Wilson Walk
208/210, 220, 230,
240 Wilson Street

A18
2 record of plan changes from march 14, 2019

Supplement Information

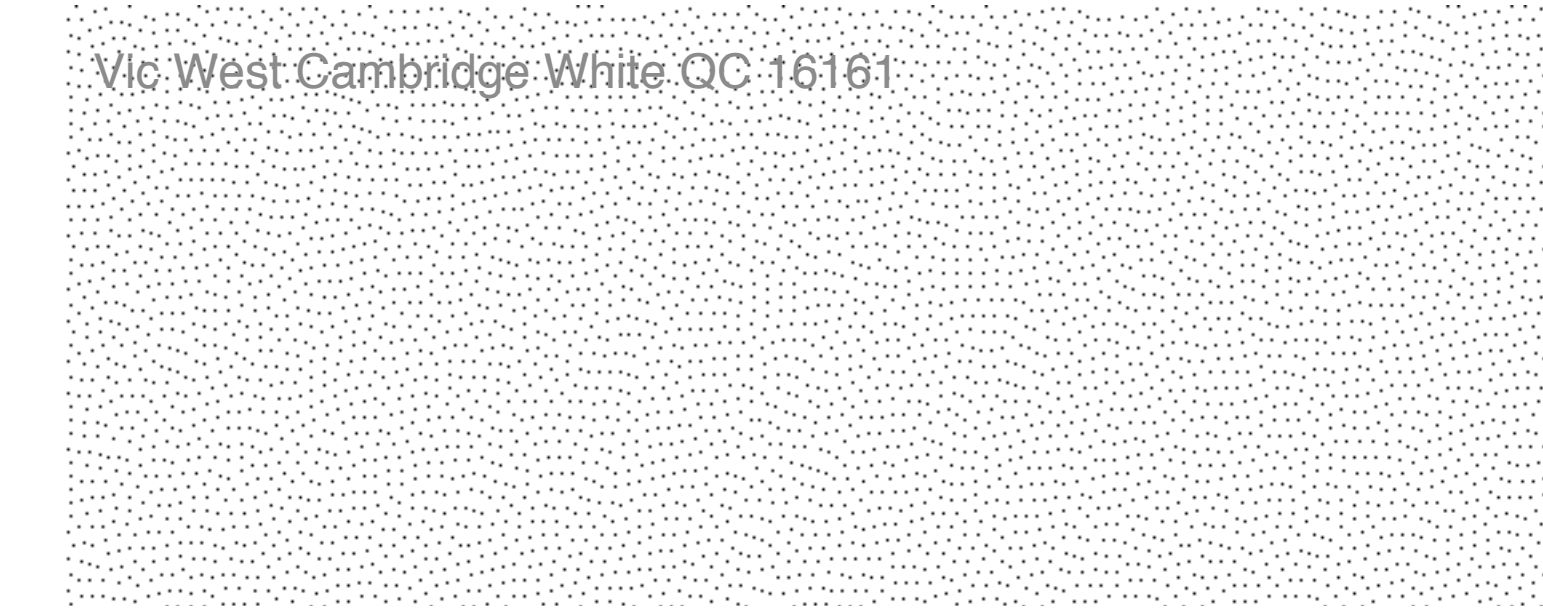
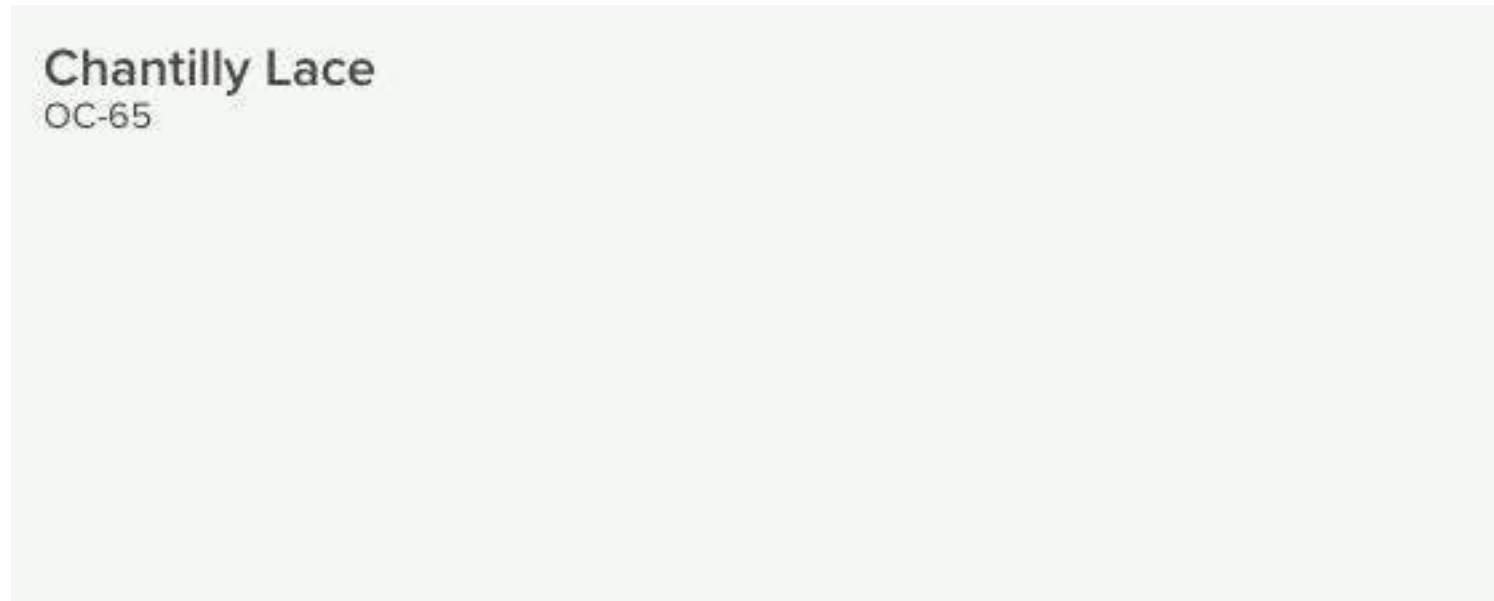
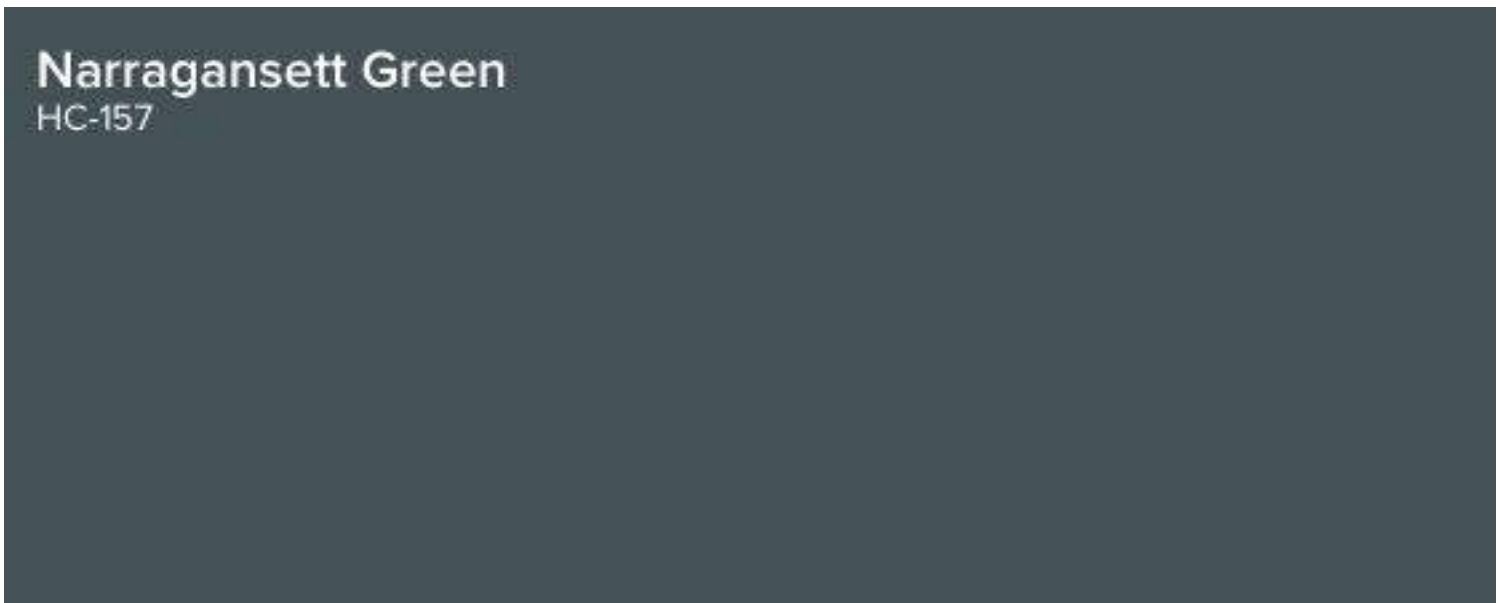
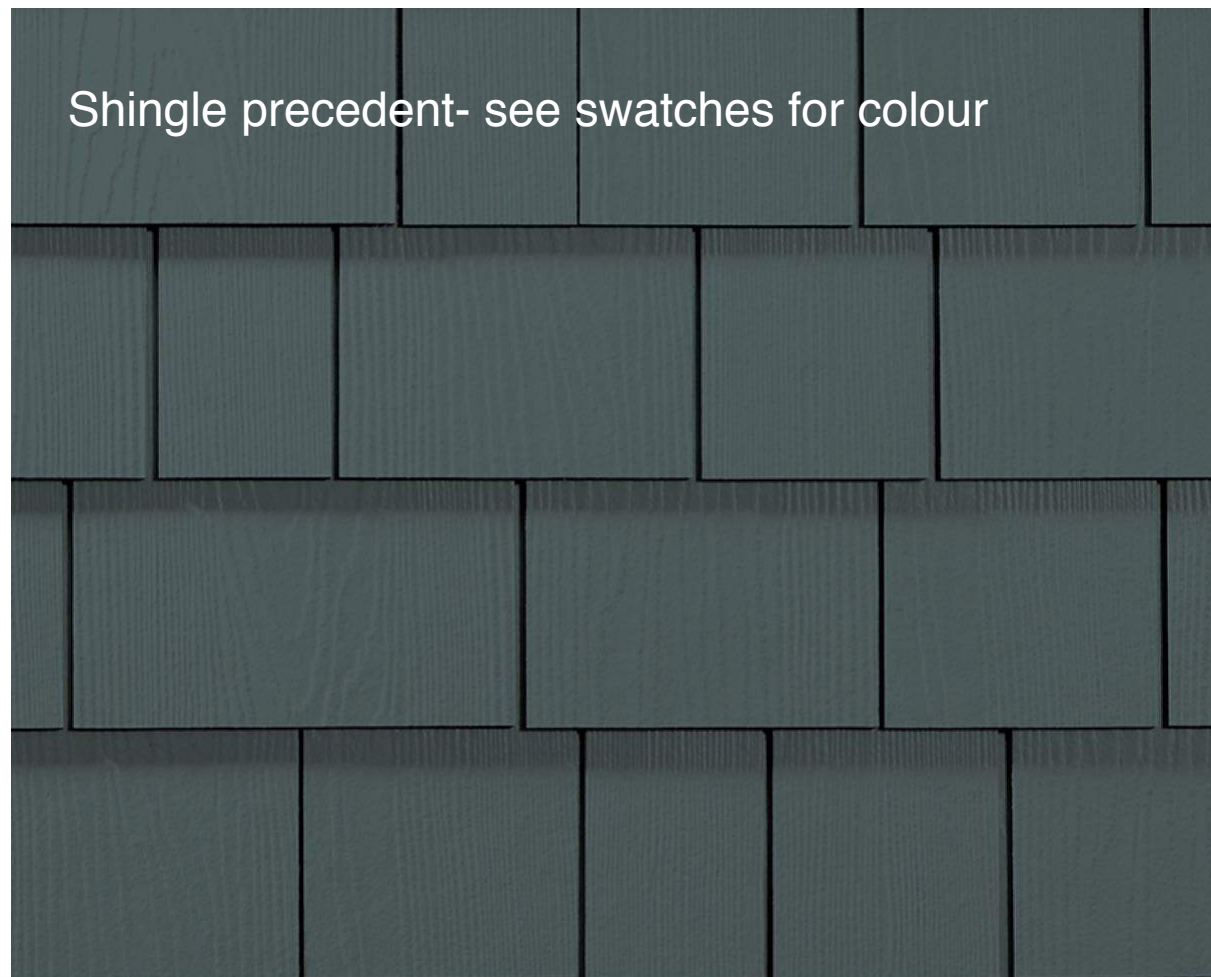
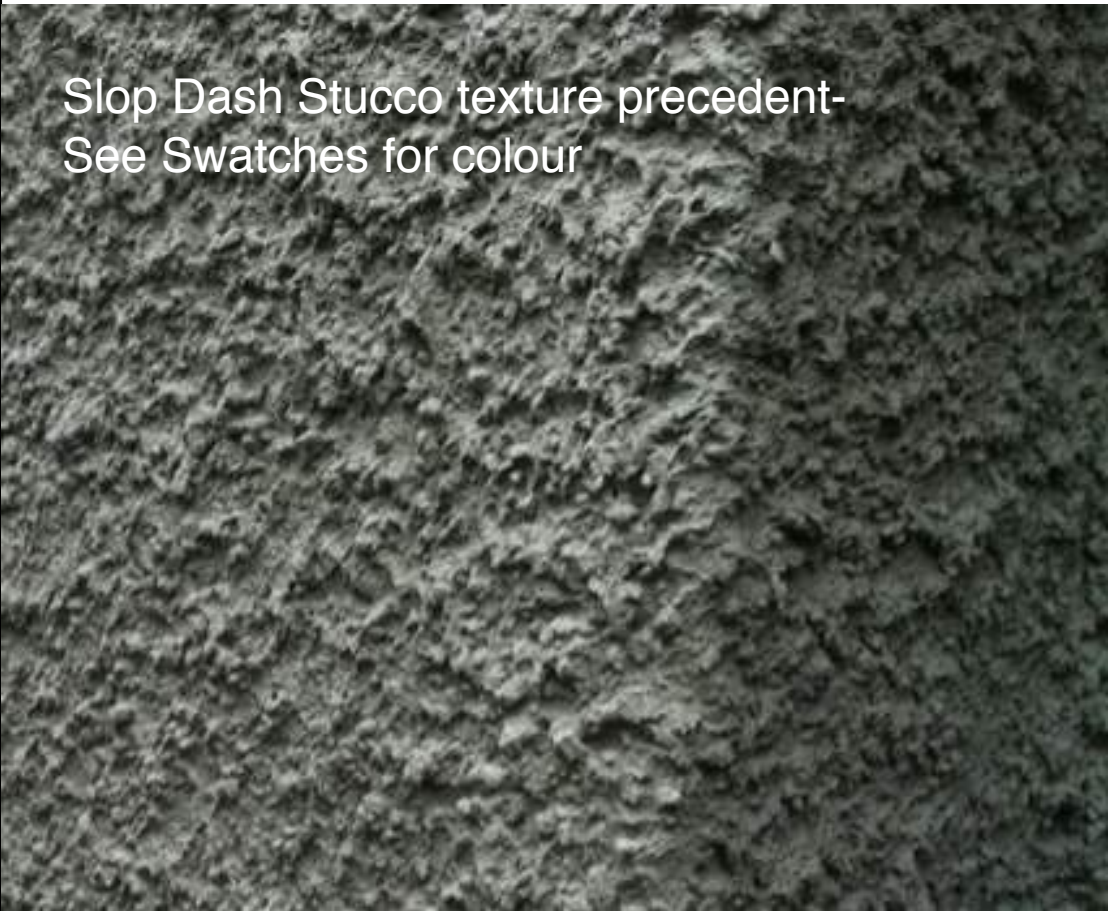
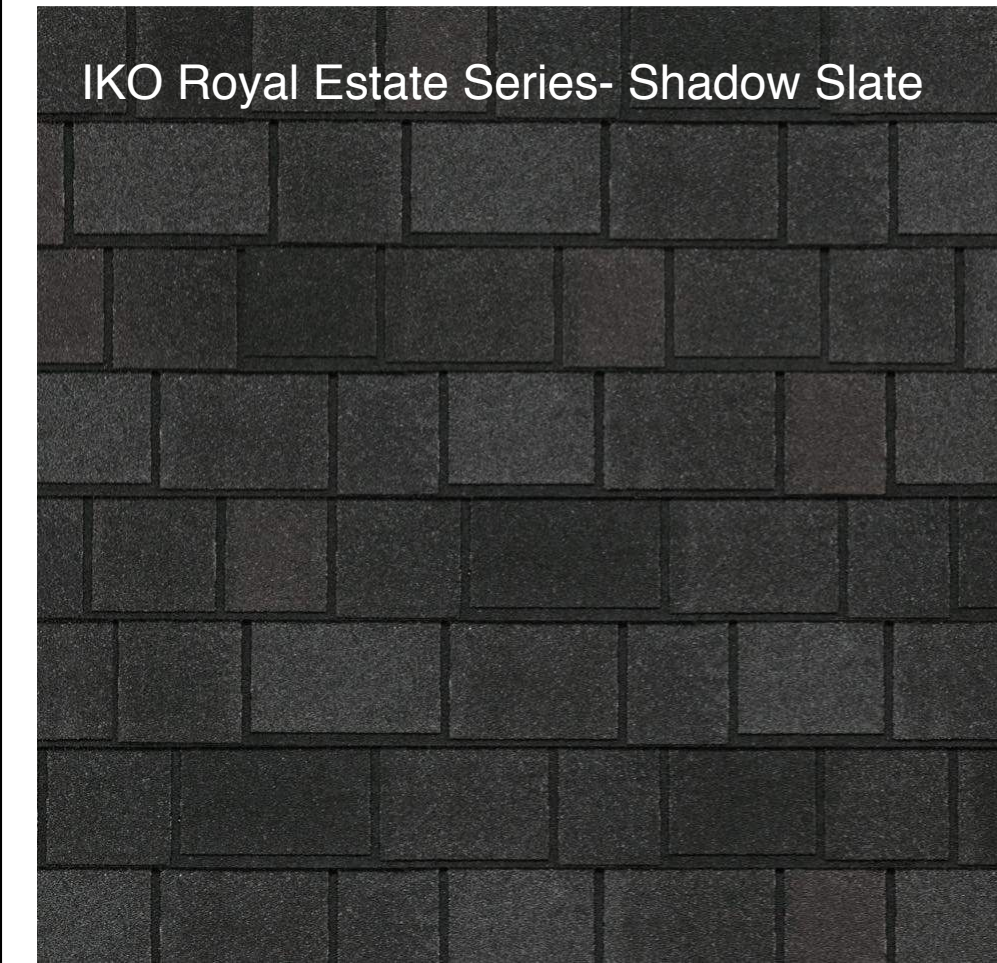
List of Plan changes		
Revision	Page	
1	A01	added keypad for guest entry to access 1 guest parking stall below
2	A01	area of parkade that will be above existing grade is now noted in grey. Parkade will be entirely below finished grade
3	A01	unit numbers changed to account for bachelor units being sold as separate strata unit. This has been shown to be more favourable to council
4	A01	See civil drawings for change in driveway as well as detail 3 on A18. drive aisle held to 8% in order to confirm to parking bylaw.
5	A01	Project site data table updated: 1)added site coverage including parkade above original grade, 2)bachelor suites have been separated out to have their own unit number as they are proposed as separate strata units now. The are below 1.8m so the square footage is not calculated in the FSR.
6	A07	All perspectives have been updated with more realistic and suitable trees and plantings. Please see civil for all road and sidewalk details/ curb cuts, etc.

7	A08	door was removed and locking gate was introduced to increased ventilation as per consult with mechanical engineering. Total travel distances were re-calculated and are conforming to BCBC2018
8	A08	Gridlines were added to all floor plan layouts typ. to add clarity.
9	A08	example of Wilson Walk Project signage on East side of north building to add further clarity to that building face given questions brought up during ADP review.
10	A10	units 29-34 main floor elevation was raised to allow for better clearance/access into parkade. Jim requested that we allow for any possible increase that could be required given structrual engineering requirements at this stage rather than later so we have.
11	A11	units 29-34 upper floor elevation was raised to allow for better clearance/access into parkade. Jim requested that we allow for any possible increase that could be required given structrual engineering requirements at this stage rather than later so we have

12	A12	roof pitch was changed from 12:12 to 10:12 to keep height of building consistent from what was shown previously given the requirement to raise both the main and upper floors to create better parkade headroom clearance at entry door.
13	A17	changes to height calculations and floor elevations as per above revisions 10 & 11
14	A18	Detail 3 was updated to show how we are complying with drive aisle slope % max as per parking bylaw.
15	A20	dimensions were added in parkade cross sections to better show that we are meeting our 2.1m height clearance requirement. The engineers and architect are well aware of the head clearance requirements and we are and conforming.
16	A22	added detail for front entry stairs from south building leading to sidewalk on Wilson as per feedback from ADP review. Spindle change, dimensions, profiled top cap, return at bottom of stairs and eased transitions.
